Access Assessment Report

72-74 Maitland Street, Muswellbrook – Stage 1

Reference No: 111917-Access-r04

Date: 20 September 2021

Figure: Accessible door clearance.

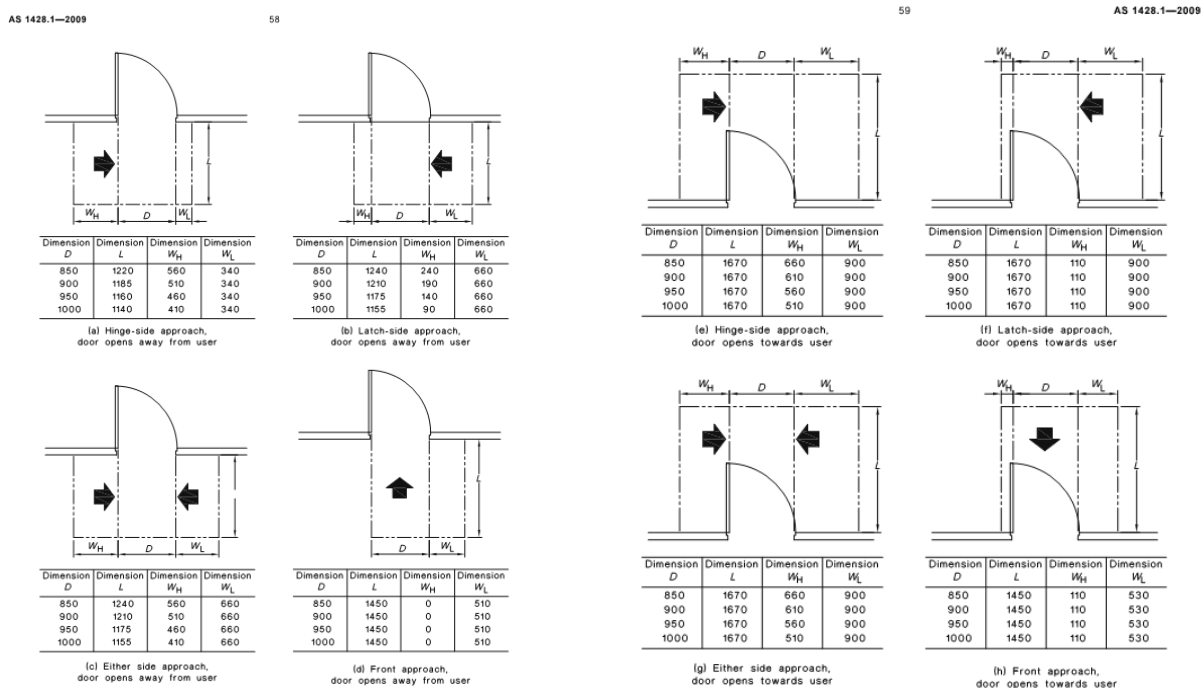
Each Classroom door clearance & the door clearance of the unisex accessible WC, located within the student amenities block, is to achieve a minimum clear width of 850mm with circulation spaces on both sides of the door complying with Clause 13 of AS1428.1-2009 (illustration below):

Figure: Typical stair and handrail design.

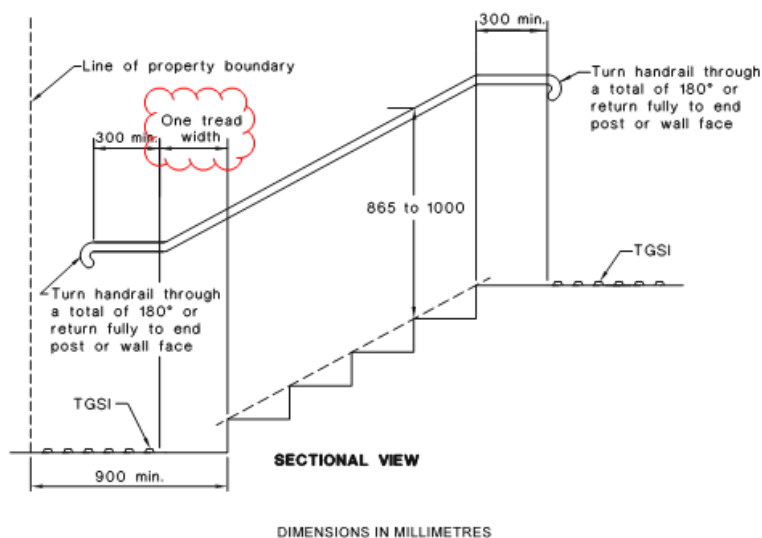
Currently, the design will need to incorporate kerb rails along each handrail where the handrail does not terminate at the top of the ramp, but rather continues along the remainder of the deck space outside each classroom.

Currently, the handrail design of the stairs will need to include a 300mm continuation at the base of the stairs.

Figure: Accessible car parking requirements.

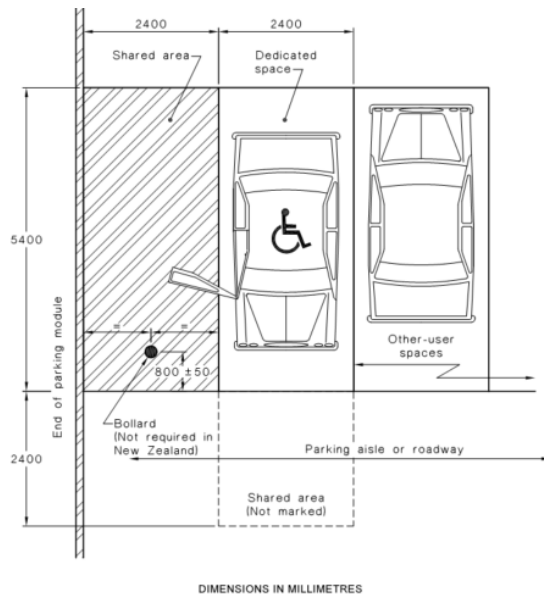
Initially Stage 1 works proposes a total of 13 carparking spaces as part of the development, of which one has been nominated as an accessible parking space. This sizing, provisions for a shared zone with a bollard, identification signage, and line markings are to comply with the requirements of AS2890.6 for

accessible parking spaces. This generally requires a minimum width of 2400mmx5400mm, with an accompanying shared zone next to the nominated space. In addition, the standard requires all line markings to the shared zone to be in yellow coloured slip resistant paint.
